SoundOff Water Intrusion

Parts Update #17-07

SoundOff Lighting – Side Directional

FIGURE #1

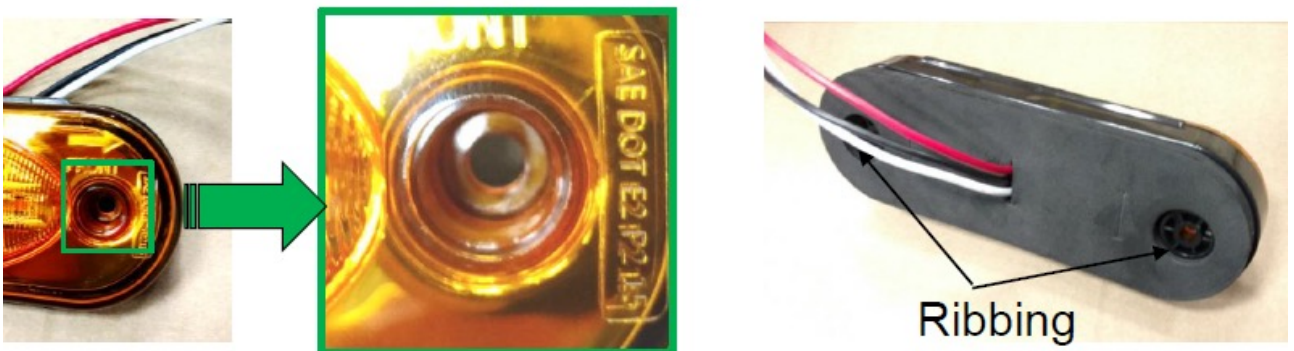
SoundOff has however done testing and determined that **“Current design has highest stress points at the weld joints between the base and the lens, which is increased as torque is applied to the installation screw. Cracks result from torque on installation screws and are a path for water to enter the light.”**

Below in FIGURE#1 you can see the current design where the screw holding the light would contact the light backing and cause the lens to pull away from the back and cause water intrusion.

Testing was done and their engineering designed a solution where the **“Redesign the lens/base interface to prevent the screw from increasing the stress at the welds by creating a step in the lens for the screw to seat on. Add ribbing to back of light to make the base more rigid to reduce flex during installation.”**

When doing the testing and comparing the new design to the previous design they found the current light had failures below 18 in/lbs of torque where the new design had “ZERO” failures through 54 in/lbs of torque.

FIGURE#2 shows the redesign where the screw actually seats on the lens and added “ribbing” on the backing plate at the screw holes to address screw torque.
